Re: Monroe-Woodbury Central School District
2023 Bond: Phase 3 – NMES
CPL R23.15292.00

ADDENDUM #3

Drawing Number
NMES
A203

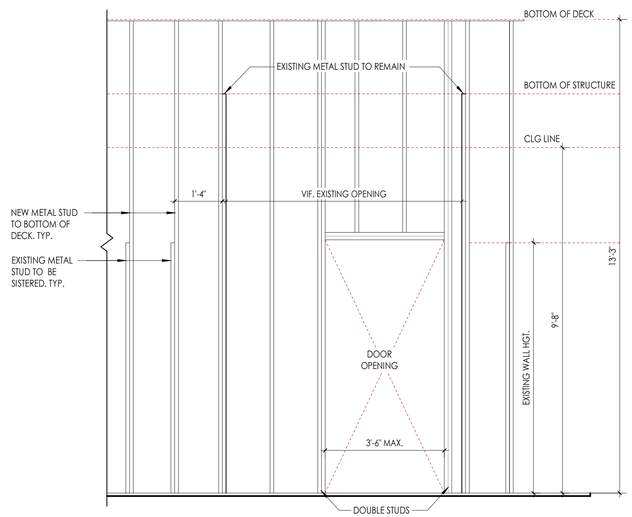
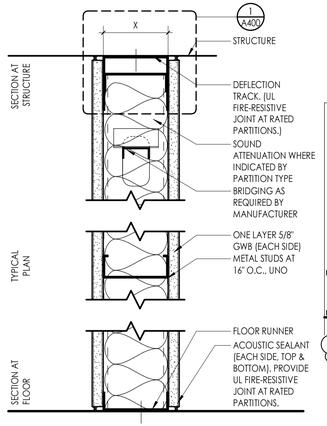
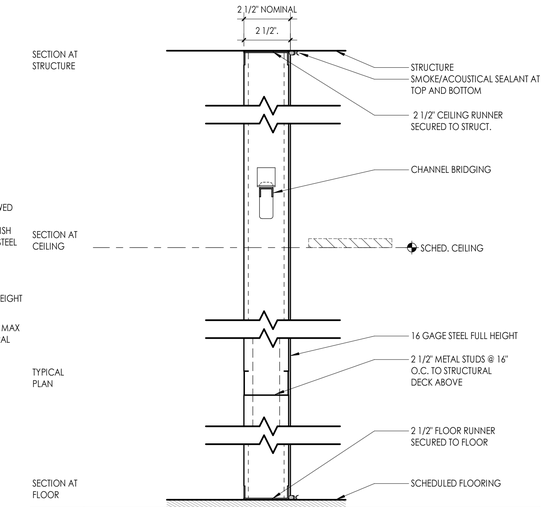
RFI-010	2	Please provide the project milestone schedule.	See Addendum 1
RFI-011	2	General Note #4 at the top of Sheet A400 calls for minimum 18 ga metal studs. The enlarged partition type details on the same sheet call for 16 ga. Please confirm that 16 ga metal studs are required for all new interior framing.	18ga @all interior wall. 16ga @all pipe chase enclosures
RFI-012	2	Detail 4/A400 applies to the corridor walls that get new gypsum board on the corridor side. These walls also get a layer of gypsum board on the classroom side, up to the classroom ceiling height. Please clarify the following: 1 - What is the existing wall height? 2 - Is the new gypsum board to be installed over the existing framing, with the existing studs to remain? 3 - Are any existing wall finishes to be removed before the new board goes on?	Refer to sheet A400
RFI-013	2	Roofing bid form doesn't list a space for the MPC-4 new split system HVAC for kitchen alternate. Please update.	See Addendum 2

Drawing Number
NMES H803

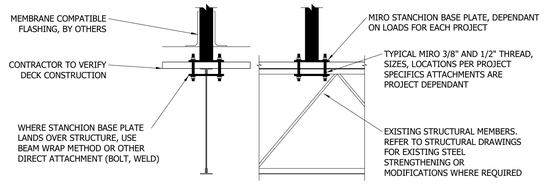
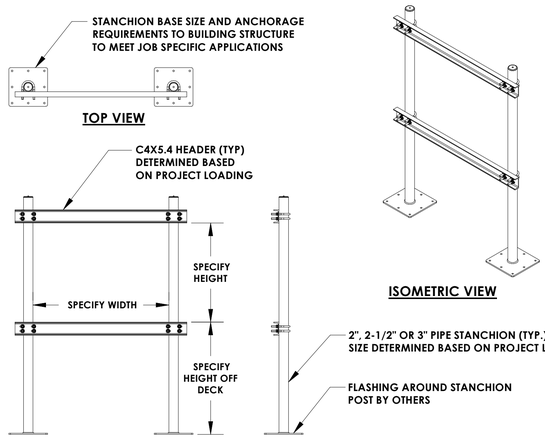
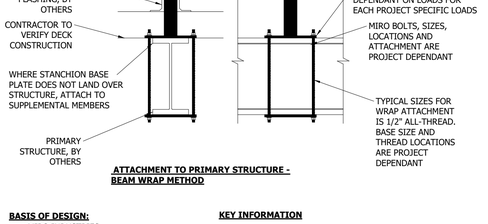
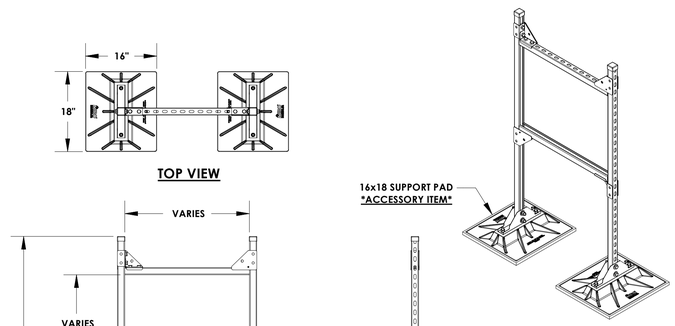
15. Ref Note R6 on A205, which contract owns the deck infill and interior ceiling work?	See Multiple Contract Summary
		16. Ref A803 and H803. Both drawings show duct support details. Which contract owns providing the supports?	MC to furnish RC to install - See Multiple Contract Summary

1 / P000 **VENT THROUGH ROOF DETAIL**
12" = 1'-0"

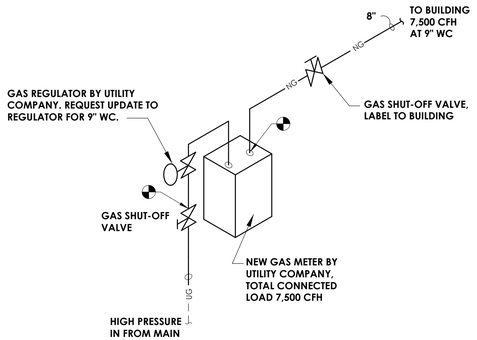
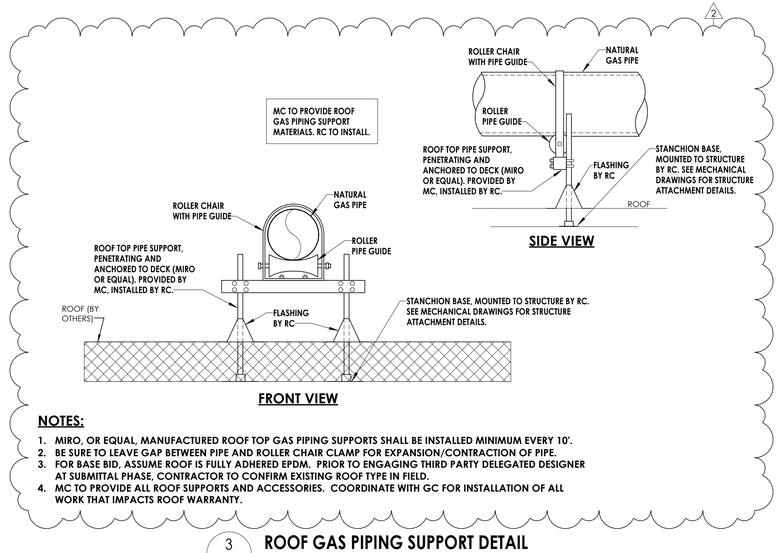
2. 6/A800 shows a rail support for piping. Detail 3 on P000 shows roof gas piping supports with U-Anchor and guy wire bracing. Which detail should be used? Also, please clarify which contract owns the required supports and/or anchors.	See Addendum 2 and Multiple Contract Summary
